MIAMISBURG CLOSURE PROJECT RISK BASED END STATE VISION

DRAFT
February 2004

Figure 4.0a Site-wide hazard map - current status

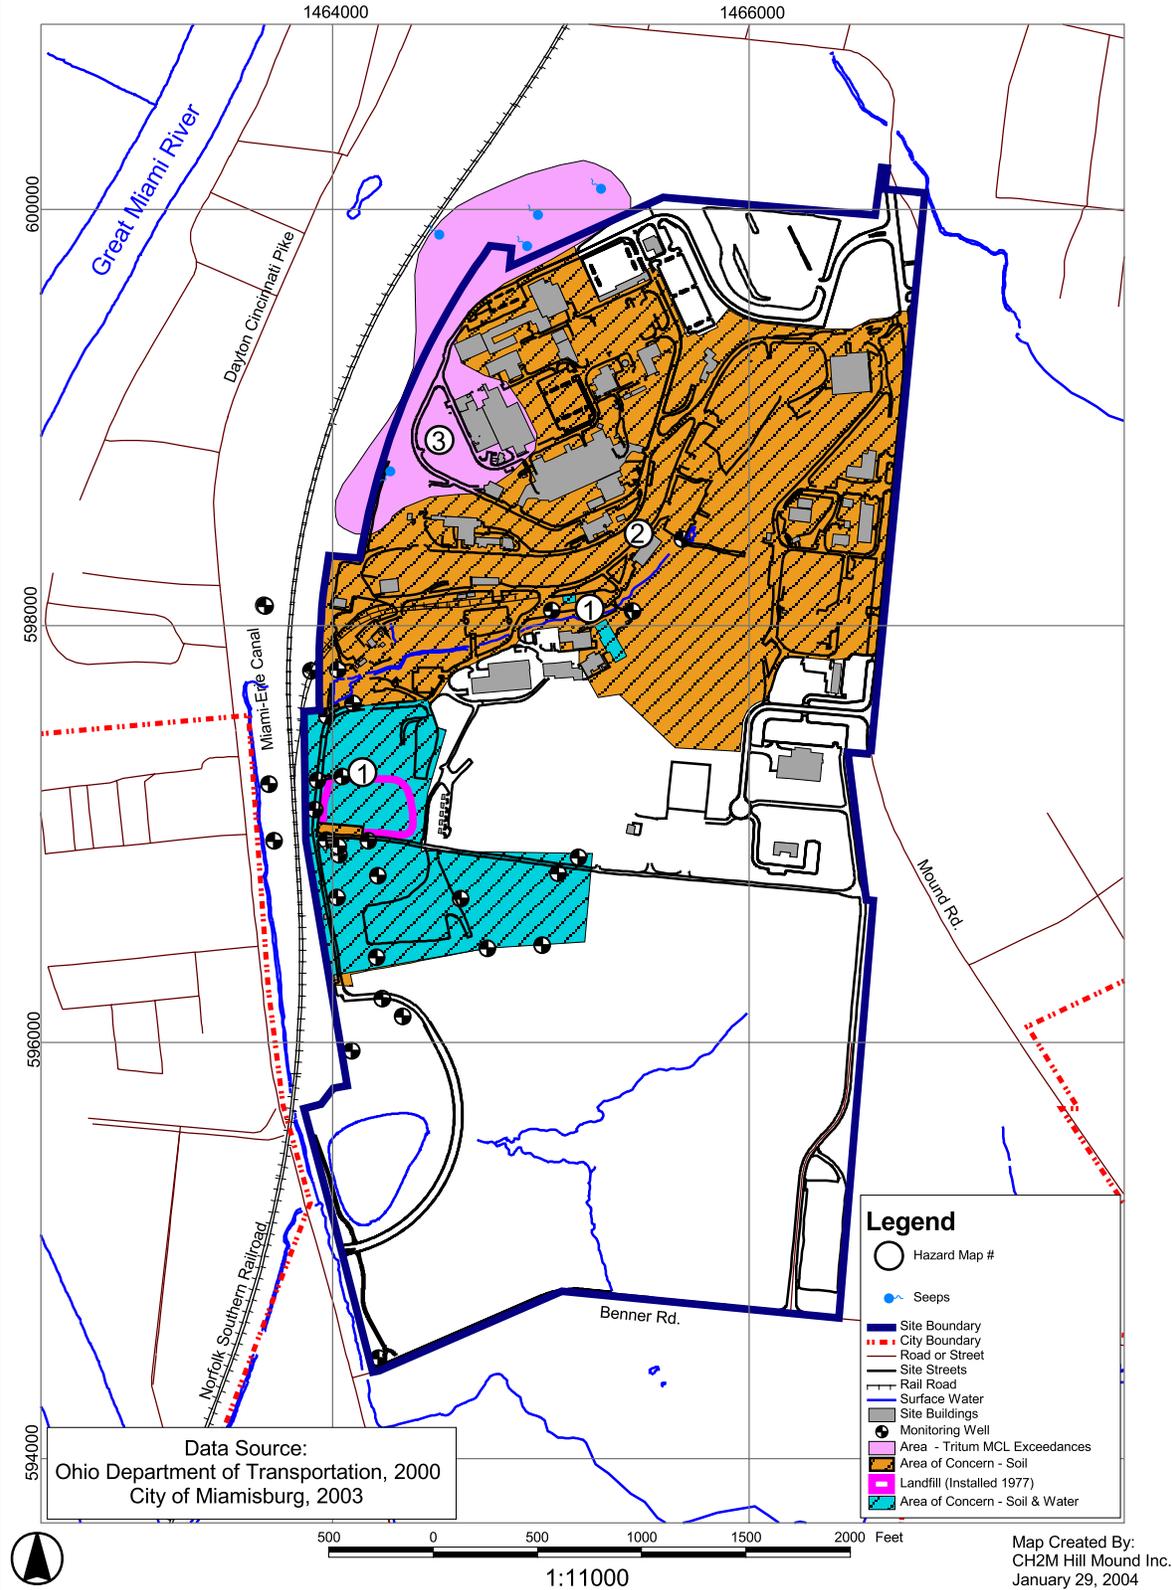
30. Figure 4.0a. 1) Legend clarification – change landfill to mixed waste landfill. 2) The area of groundwater concern extends beyond the site boundary. This should be corrected on the map. 3) Two hazard areas are insufficient to characterize the site.

30. Figure 4.0a. 1) Legend clarification – change landfill to mixed waste landfill. 2) The area of

33. **Figure 4.0a** – Incorporate well 411, 443 and seep 617 as Hazard 1 areas. Remove the Phase I b area from the Hazard 2 area. Place Parcel 6 in the Hazard 2 area. The current Hazard 1 area should reflect radioactive contamination in soil.

33. **Figure 4.0a** – Incorporate well 411, 443 and seep 617 as Hazard 1 areas. Remove the Phase I b area from the Hazard 2 area. Place Parcel 6 in the Hazard 2 area. The current Hazard 1 area should reflect radioactive contamination in soil.

26. Figure 4.0a. What is the basis for the orange colored strip along the western portion of OU-1? This is an extension of the radiation area of concern. What PRSs does this correspond to?

13. **Figure 4.0a** – Incorporate well 411, 443 and seep 617 as Hazard 1 areas.
14. **Figure 4.1b2** – Source term reduction is not a mechanism to block an exposure pathway. The exposure is still there, just at an acceptable level, in this case. Remove all references to blocked pathways that do not apply.

Figure 4.0b Site-wide hazard map - RBES

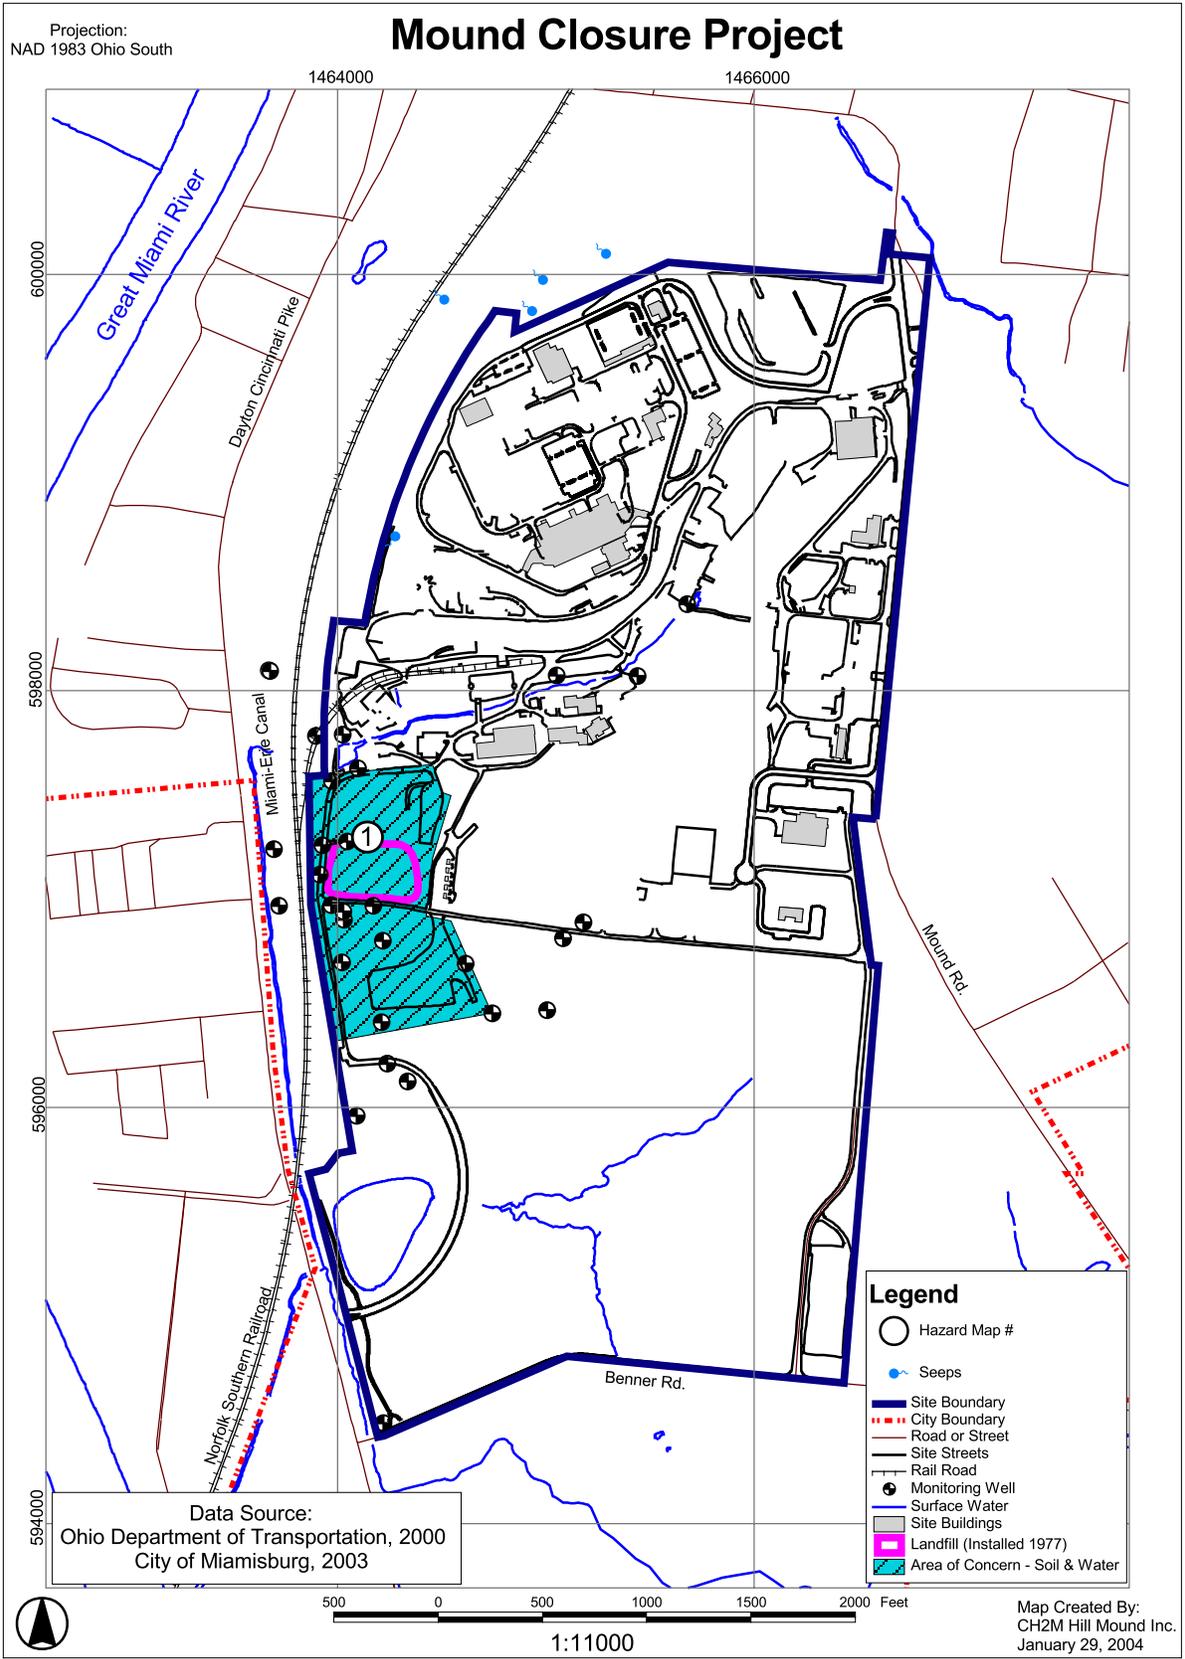
31. Figure 4.0b. 1) Legend clarification – change landfill to mixed waste landfill. 2) The area of groundwater concern extends beyond the site boundary. This should be corrected on the map.

31. Figure 4.0b. 1) Legend clarification – change landfill to mixed waste landfill. 2) The area of groundwater concern extends beyond the site boundary. This should be corrected on the map.

27. Figure 4.0b. The site wide hazard map should reflect the off-site groundwater areas that are anticipated to remain above MCLs in 2006. This should include the seeps.

Figure 4.2a1 Hazard Area 2 - Current State

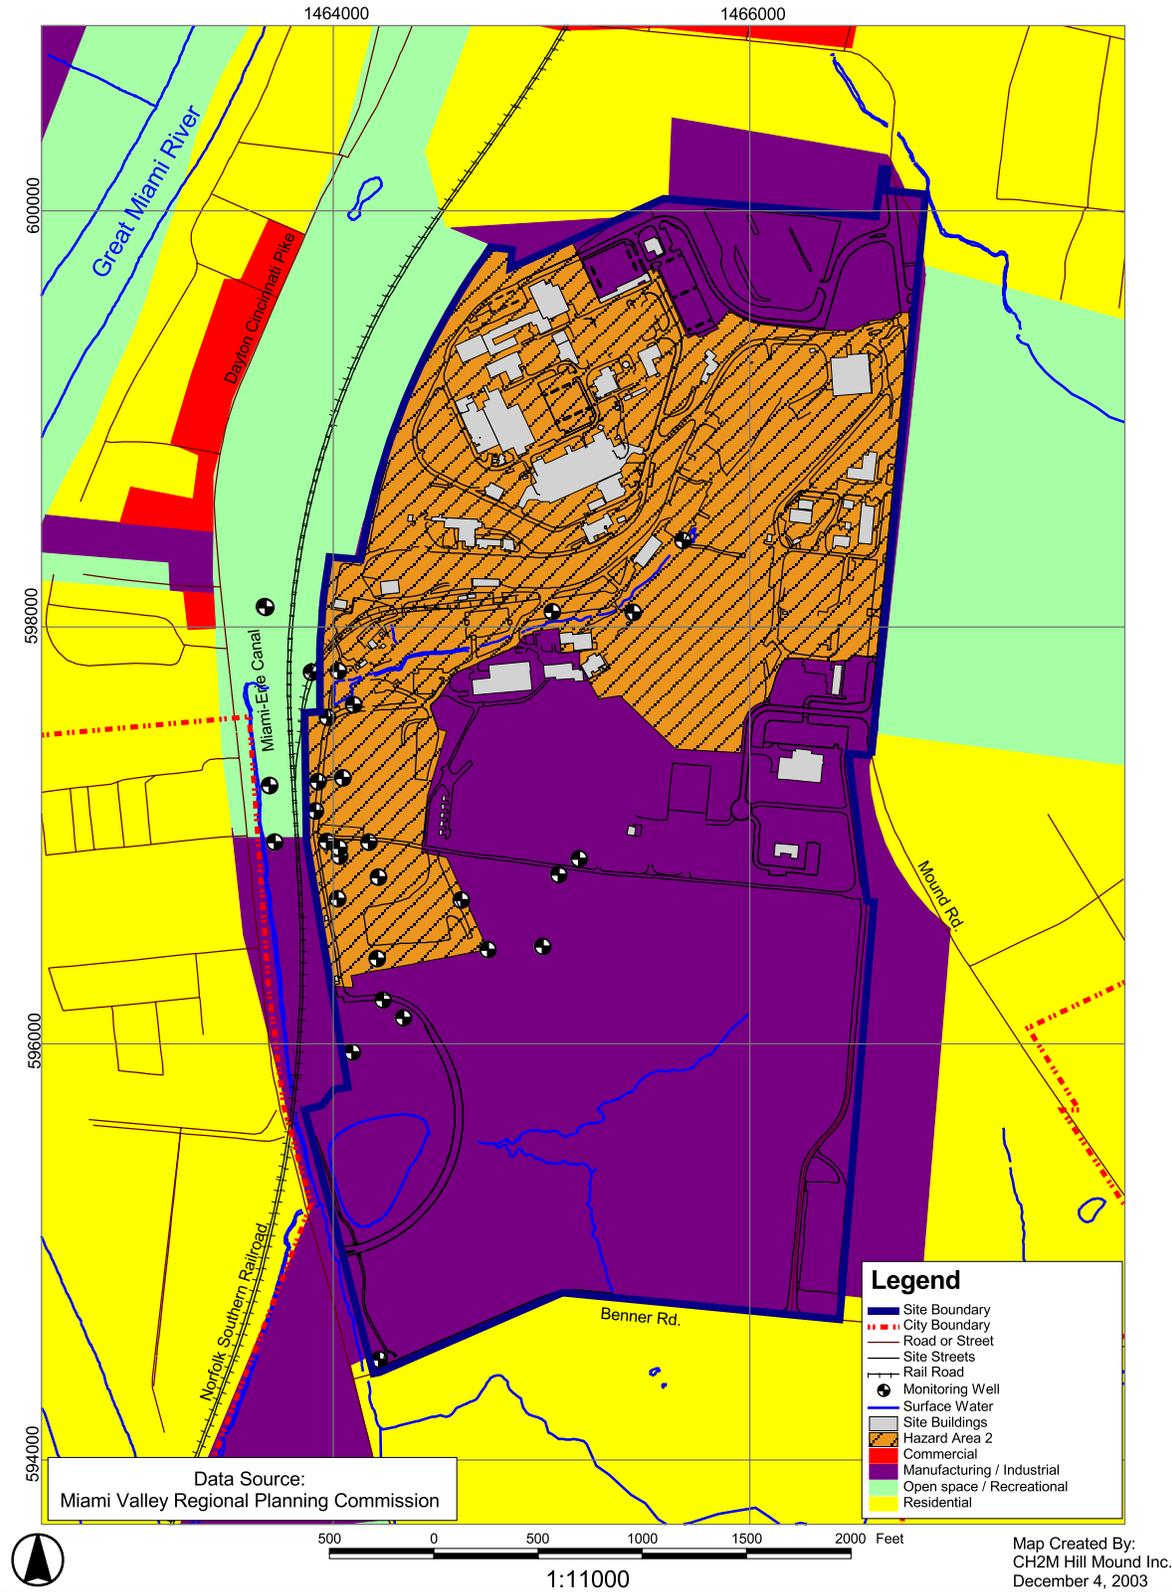
36. Figure 4.2a1. 1) Define "institutional control" as used in the legend. 2) Shouldn't hazard area 2 include the entire 306 acres?

37. **Figure 4.2a1** - Remove the Phase I b area from the Hazard 2 area. Place Parcel 6 in the Hazard 2 area.

29. Figure 4.2a1. This figure acknowledges that the entire OU-1 area is a radioactive hazard area, yet the OU-1 remedy only treats for VOCs in groundwater. Will these monitoring wells be monitored for radioactive pollutants of concern?
30. Figure 4.2b2. 1) DOE's plan to leave behind the historical landfill and the 1976 mixed waste engineered landfill does not remove the source term as indicated on this drawing. Please correct. 2) Current sampling data for the OU-1 area has huge data gaps as identified by the OU-1 Technical Team.
31. Figure 4.3b1. It is unrealistic to suppose that tritium off-site will be below MCLs by 2006.
32. Figure 4.3b2. All pathways are open. Receptors could be exposed to tritium greater than MCLs.

Figure 4.2b1 Hazard Area 2 - RBES

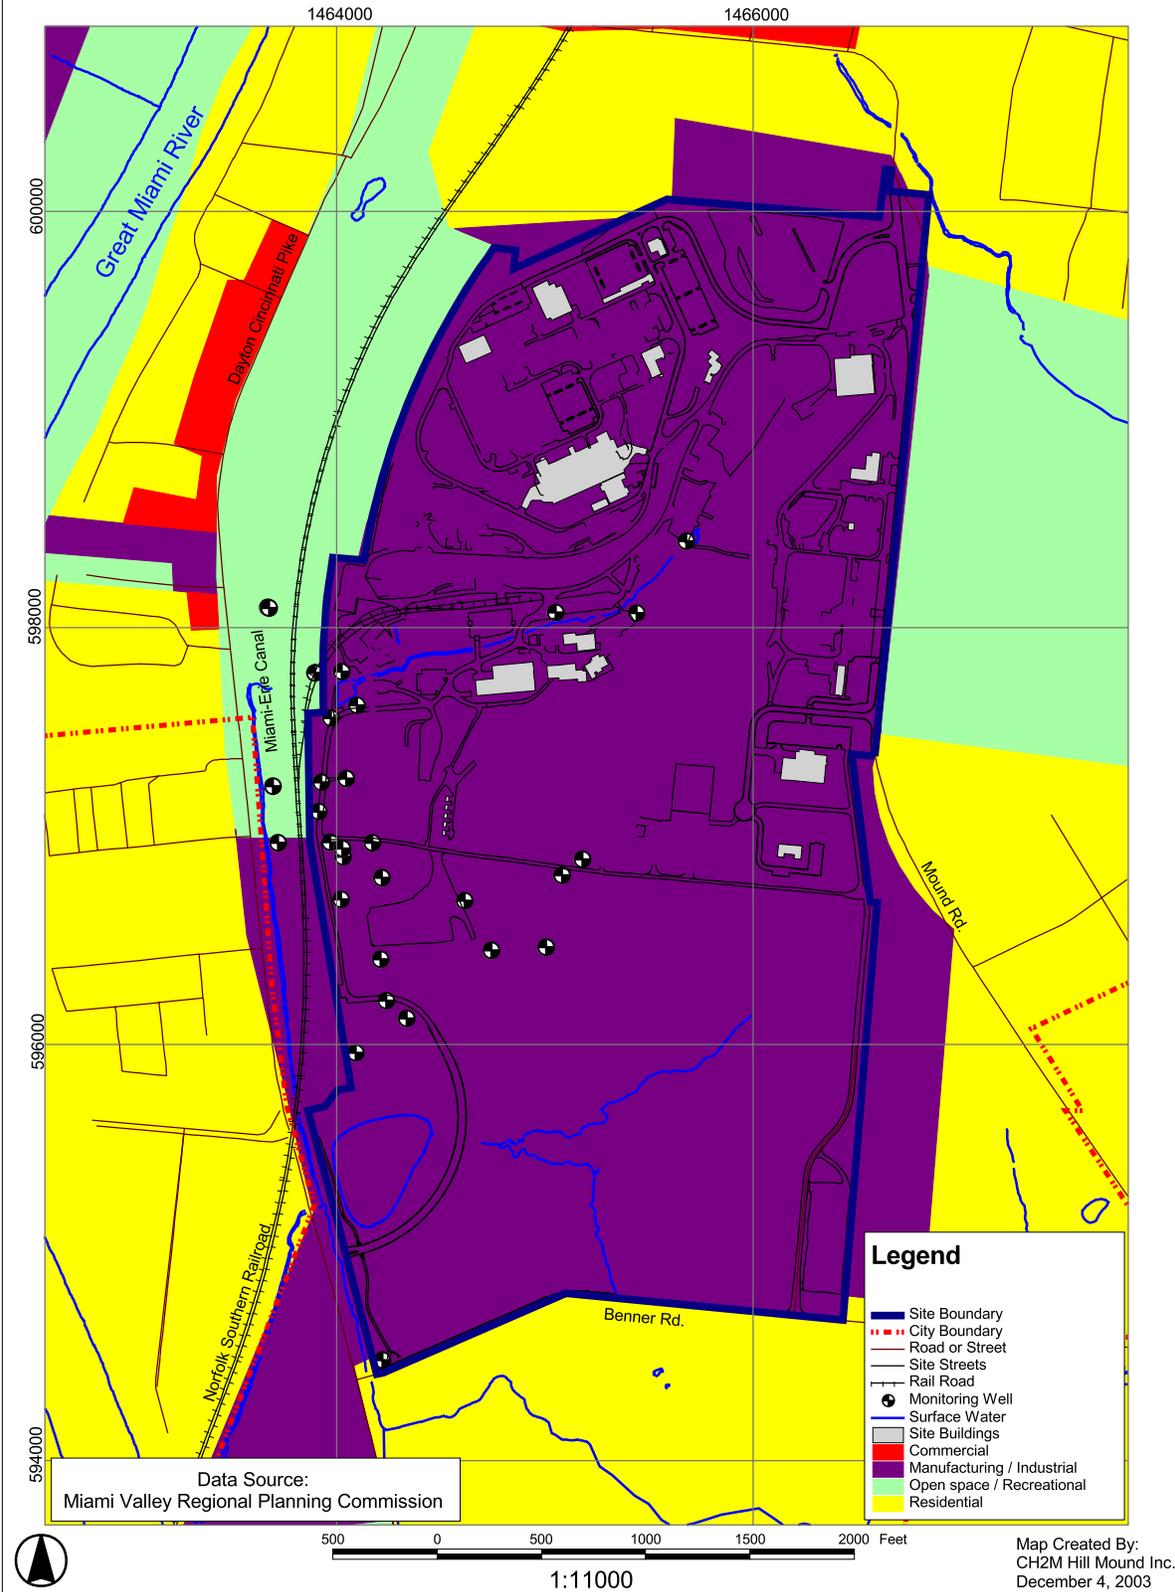
37. Figure 4.2b1. 1) Define "institutional control" as used in the legend.

38. **Figure 4.2b1** – The use designations need to be lined up with the site boundary. There is an area designated as open space/recreational within the site boundary along the canal. The area should be manufacturing/industrial use. There is also an area of residential use within the boundary along Benner Road. This should be manufacturing/industrial use.

Figure 4.0a2 Conceptual Site Model

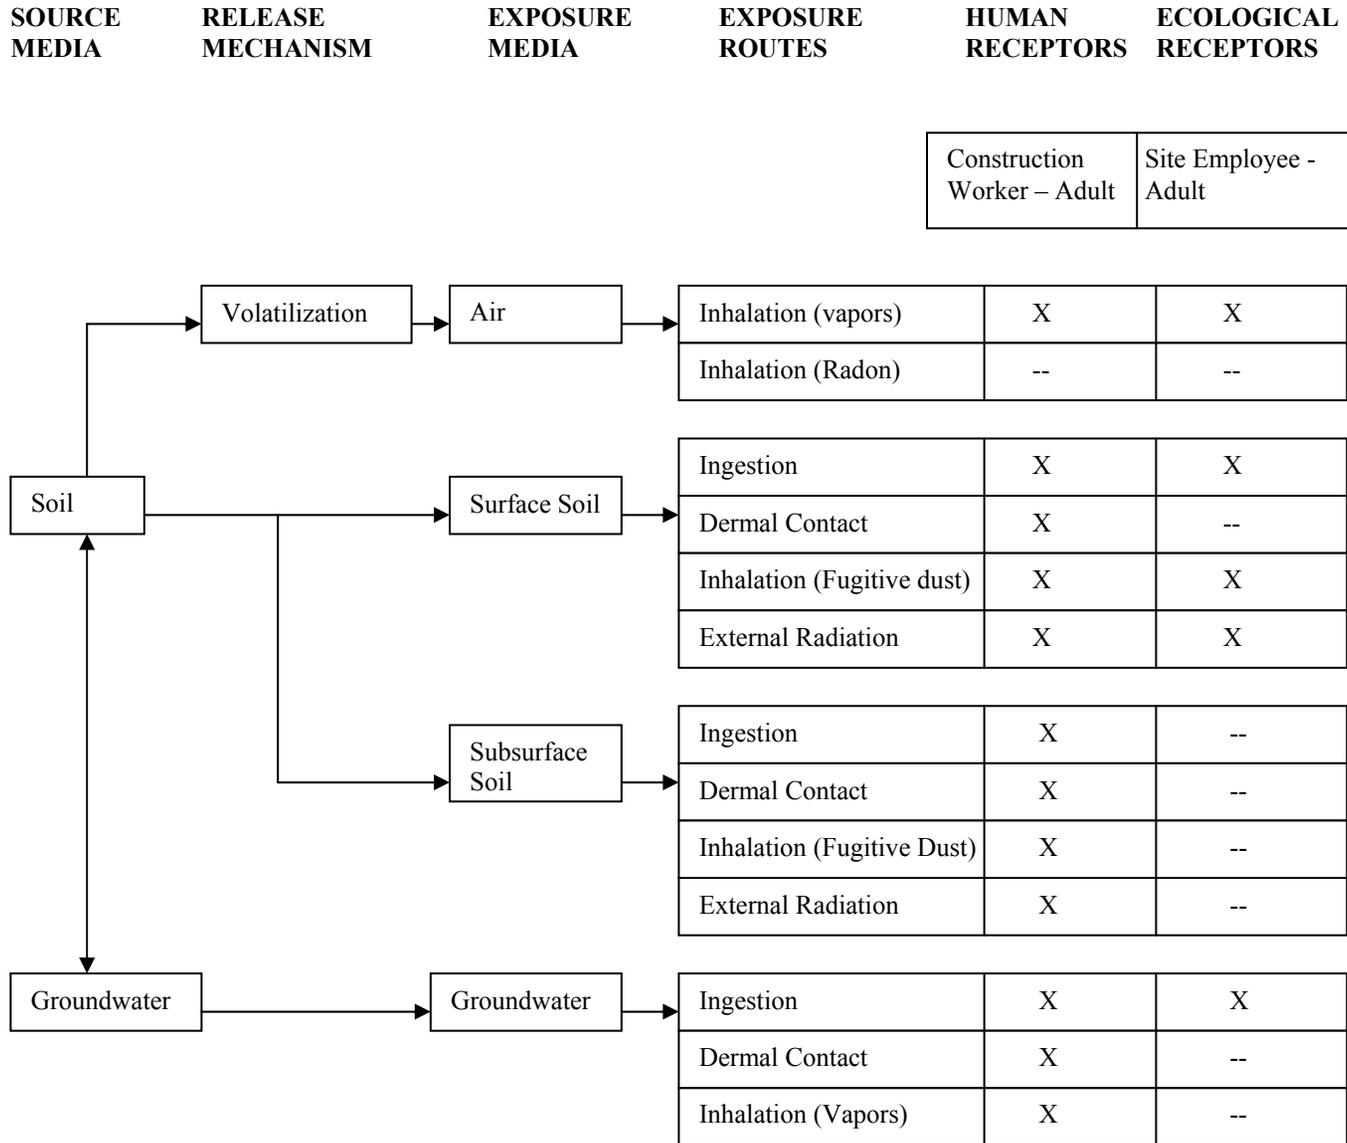
32. Figure 4.0a2. 1) Should surface water be a potential exposure media? There are surface water (ponds) and the seeps.

34. **Figure 4.0a2** – The CSM used in this figure should reflect the most recent RRE version. Please change the current/future site employee surface soil dermal contact to be an incomplete pathway. This pathway is not assessed for the site employee within the RREs. As indicated in the RREs, this pathway is assumed to be minimal if not non-existent.

34. **Figure 4.0a2** – The CSM used in this figure should reflect the most recent RRE version. Please change the current/future site employee surface soil dermal contact to be an incomplete pathway. This pathway is not assessed for the site employee within the RREs. As indicated in the RREs, this pathway is assumed to be minimal if not non-existent.
